PALISADES NUCLEAR PLANT
FUNCTIONAL DESCRIPTION
Facility Change

UTI No. 02530 50016 Plant System Code RPS FC 888
System Equipment

This Functional Description covers the replacement of all four channels of the Reactor Protection System (RPS) Power Supply Assemblies, Trip Unit Assemblies, Interconnection Modules, Bistable Trip Units and Auxiliary Trip Units. This description also covers the incorporation of Trip Tester functions into the Power Supply Assemblies. This RPS modification is required to address obsolescence concerns. The upgrade will improve RPS performance while reducing testing time and maintenance costs.

Figure 1
 RPS UPGRADE BLOCK DIAGRAM

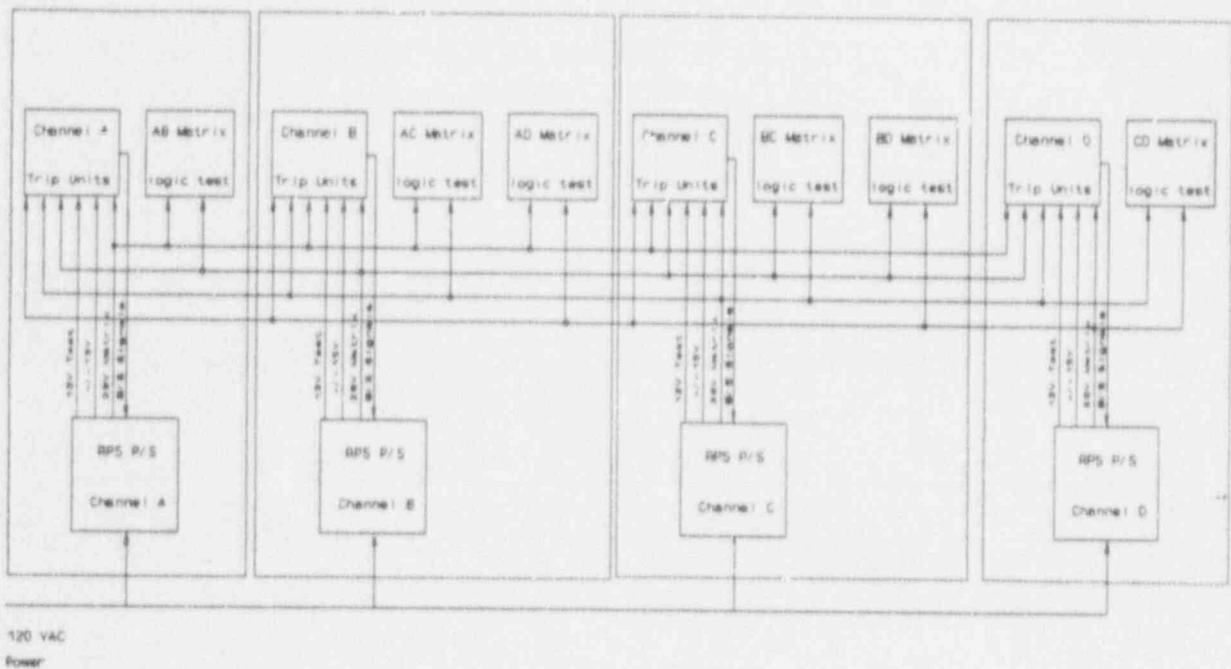
Figure 1 shows the RPS Upgrade Block Diagram. All items provided for this upgrade will be form-fit-function replacements of installed equipment with the exception of the Power Supply Assembly front panel. This panel will combine the functions that were previously contained in the Trip Tester Unit with the indications currently found on the Power Supply Assembly front panel. This

As shown in Figure 1, there will be four (4) complete sets of equipment as described below, one for each channel of the RPS. Each P/S assembly will supply a 12 VDC Test voltage, ± 15 VDC power for Trip Unit operation and 28 VDC Matrix Power. Inputs to the P/S Assembly will be the signal input to the Trip Unit, and the trip and pre-trip point voltages.

Figure 2
 CHANNEL A RPS ASSEMBLY BLOCK DIAGRAM

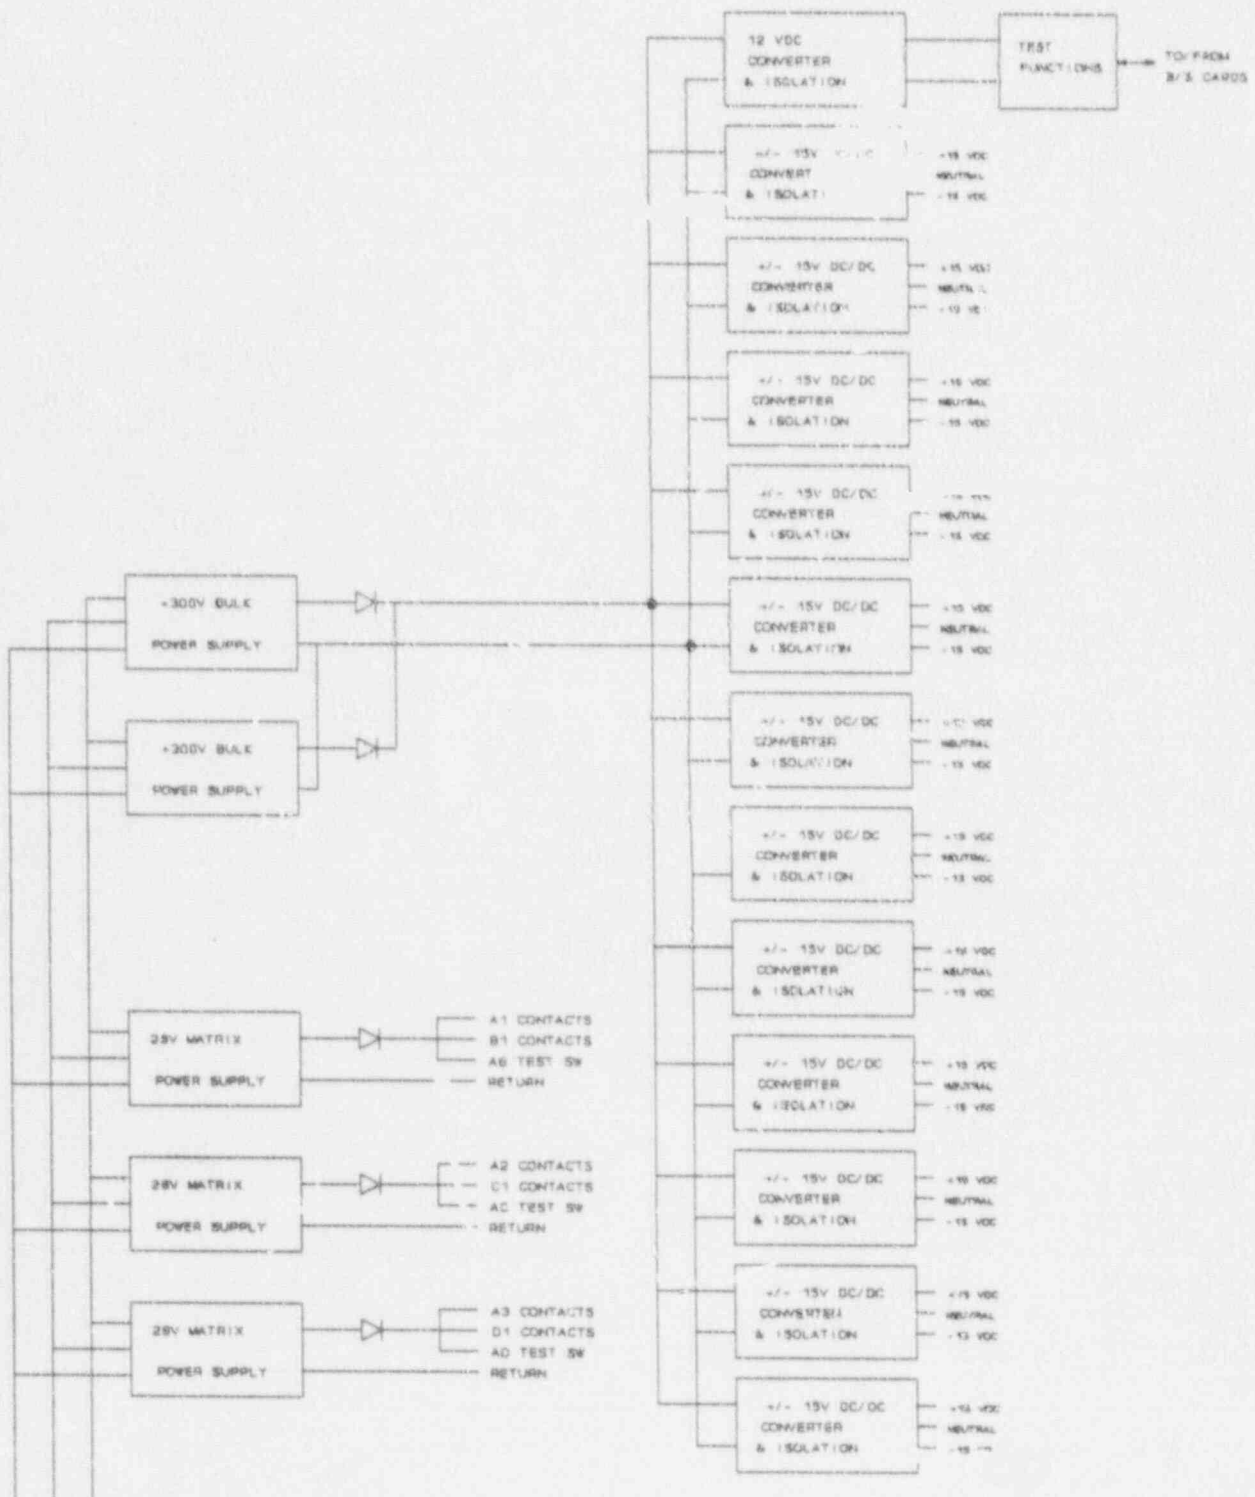
Figure 2 shows the RPS P/S Assembly Block Diagram for Channel A. This figure corresponds to the RPS P/S Channel A block shown in Figure 1. Five discrete power supplies, two (2) +300V VDC Bulk and three (3) 28 VDC Matrix, are powered off a common AC bus. The output of each of the 28 VDC Matrix Power Supplies is diode auctioneered to specific logic matrix loads as shown. The Bulk 300 VDC power supplies are diode auctioneered and supply twelve (12) ± 15 VDC converter/isolators that power each individual Trip Unit. A 12 VDC Test Voltage converter/isolator is also powered off of the +300V bulk volt supply. This supplies isolated power to the test functions in each Power Supply Assembly.

The test functions that were previously on the Trip Unit are implemented in a manner similar to that used earlier. Changes made to the former design include the rewiring of, and the addition of four (4) decks to the Trip Unit Select Switch; rewiring the TMLP Select Switch, removing unnecessary resistors and potentiometers, and adding three (3) decks and three (3) positions to the DVM Input Select Switch. The test signals are brought into the Power Supply Assembly from the Interconnection Module by MS type connectors.

The Setpoint Trip and Setpoint Pre-trip decks on the Trip Unit Select Switch are rewired to direct the signals from each of the twelve possible Trip Units to the DVM Input Select Switch. The location of the Trip Test Switch Connection to the Setpoint Trip deck is changed to the center pole. This is required in order to maintain proper function after the switch deck is

Figure 3
 TEST FUNCTIONS SCHEMATIC DIAGRAM

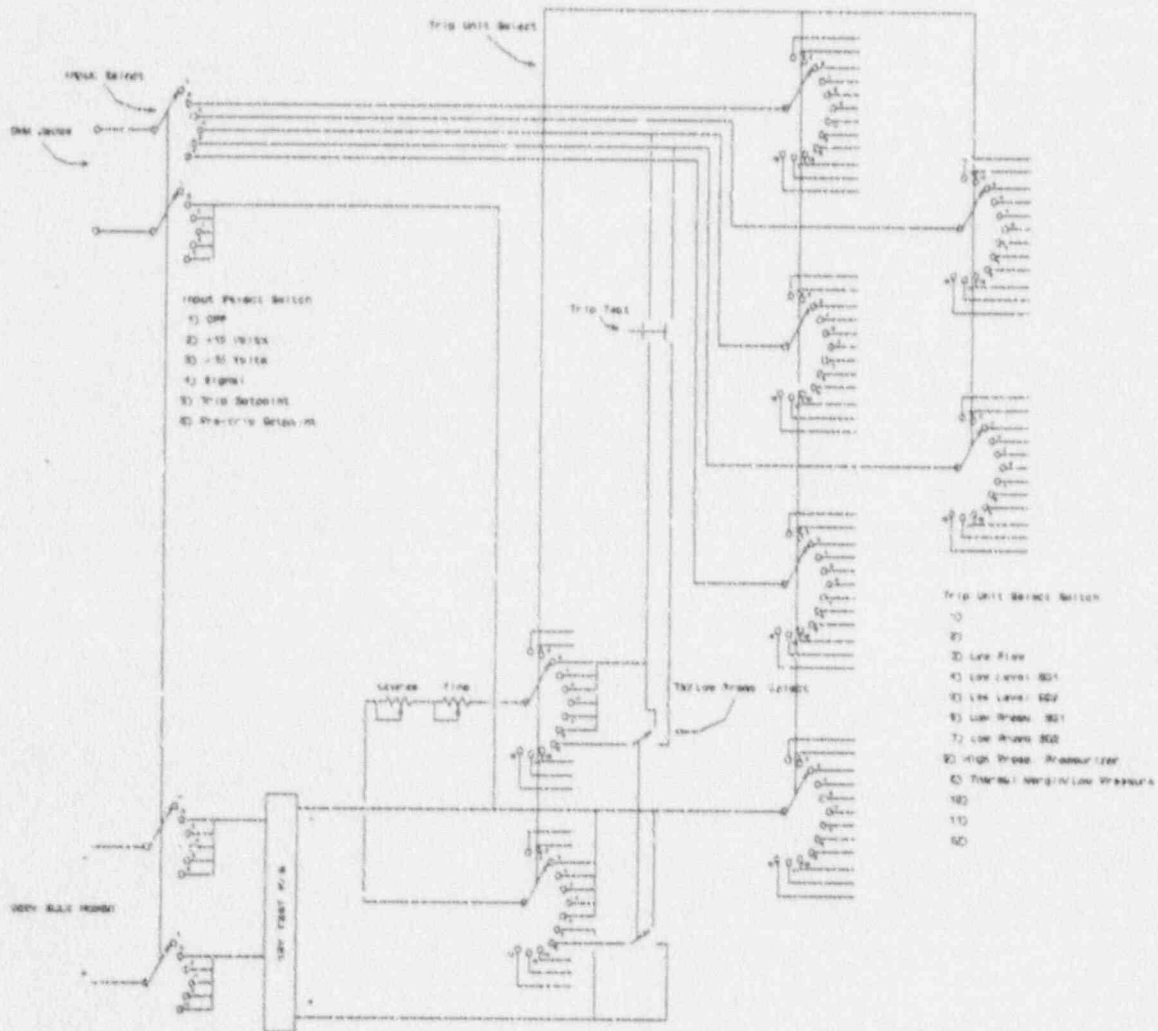
Two (2) of the decks added to the Trip Unit Select Switch are used to replace the wedicated signal and floating ground lines in the Trip Unit connection cable. Additionally, one (1) deck is added for each polarity of the 15 Volts used to power the Trip Units.

The two (2) decks on the Trip Unit Select switch that provide the proper polarity and attenuation of test voltage are rewired to provide polarity selection on one deck and power routing on the other deck. This results in the use of only one set of potentiometers and simplifies the circuit. The TMLP Switch is rewired to support the power polarity selection on one deck and the output on the other.

The three (3) decks added to the DVM Input Select Switch allow the test functions to be completely disconnected from both the DVM Jacks and the Bulk 300 VDC power. The first of the added positions is an OFF position. This is an open contact which performs the disconnect function described above. The other two added positions allow the measurement of the ± 15 Volt Power supplied to each Trip Unit. Figure 3 shows the implementation of the test functions.

Figure 8
POWER SUPPLY FRONT PANEL LAYOUT

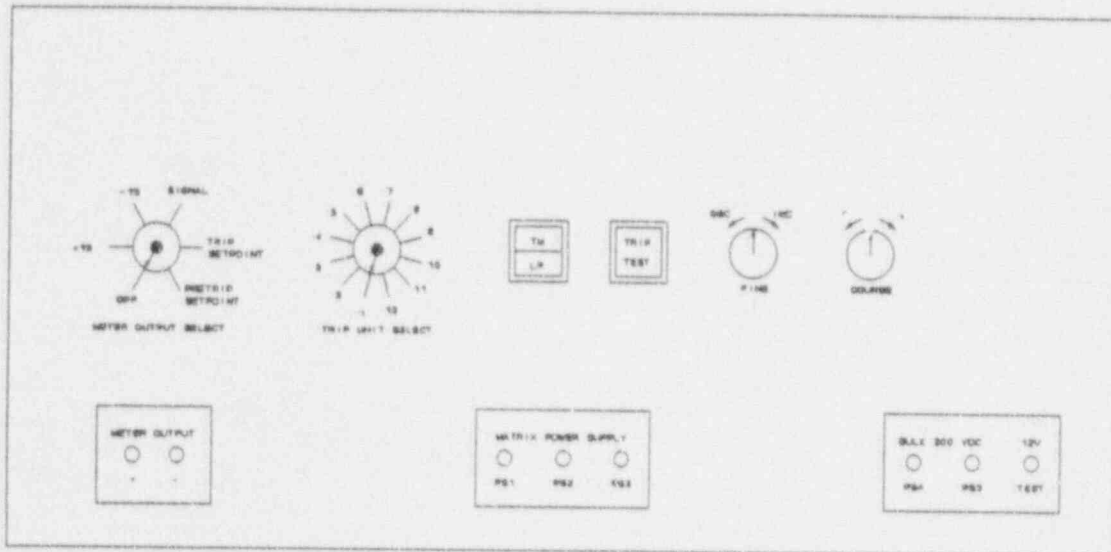
The RPS Power Supply Assembly Front Panel is shown in Figure 8. The panel incorporates the Matrix Power Supply indication found on the present system with the Trip Tester Unit functions.

Indications found on the front panel are LEDs for each of the three (3) 28V Matrix Power Supplies, both of the 300V Bulk Power Supplies and the 12V Test Power. A dual banana jack is provided for DVM connection to the test functions.

Controls on the front panel are the Trip Unit Select Switch, Meter Output Select Switch, TMLP Switch, Trip Test Switch, and Course and Fine Potentiometers.

The TMLP Switch and Trip Test switch are functionally unchanged. The wiring of the TMLP Switch was changed to accommodate the rewire of the Trip Unit Select Switch. This change allows the use of only one set of Potentiometers for upscale or downscale trip testing.

Figure 9
RPS POWER SUPPLY ASSEMBLY LAYOUT

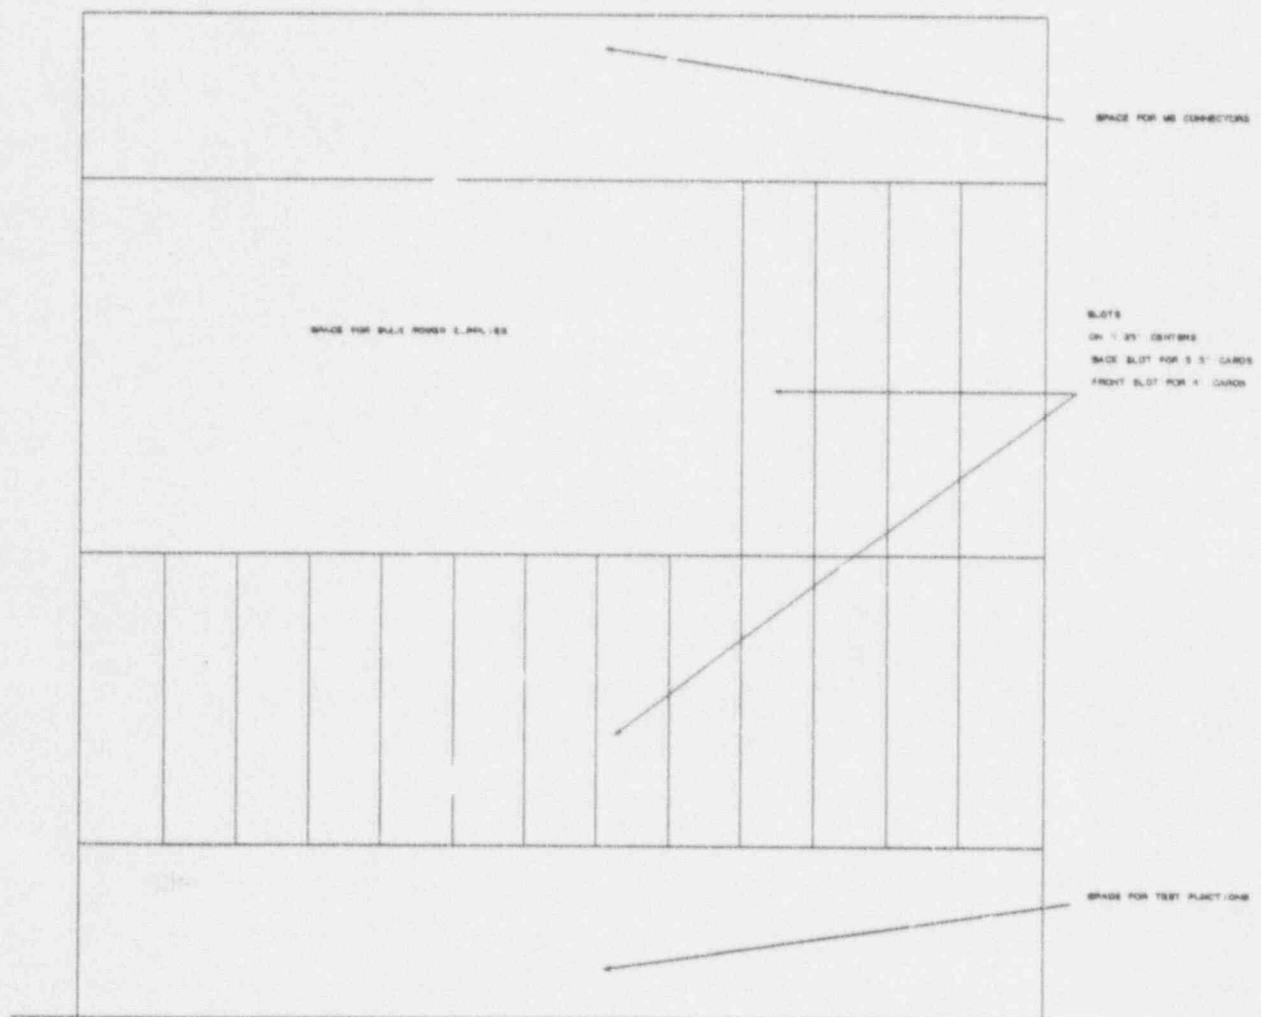
A power switch located on the top of the power supply drawer will remove all AC power to the PC Cards.

The general layout of the RPS Power Supply Assembly is shown in Figure 9. The Assembly is divided into three parts. The rear of the Assembly holds the 28V Matrix Power Supply cards, the +300V Bulk Power Supplies and the 12V Test

Power Supply card. The middle area of the Assembly holds the $\pm 15V$ converter/isolators. Each card type has a specific pin configuration to ensure that each type will operate only in its respected location. The front area provides space behind the front panel for the individual components required for the test and indication functions.
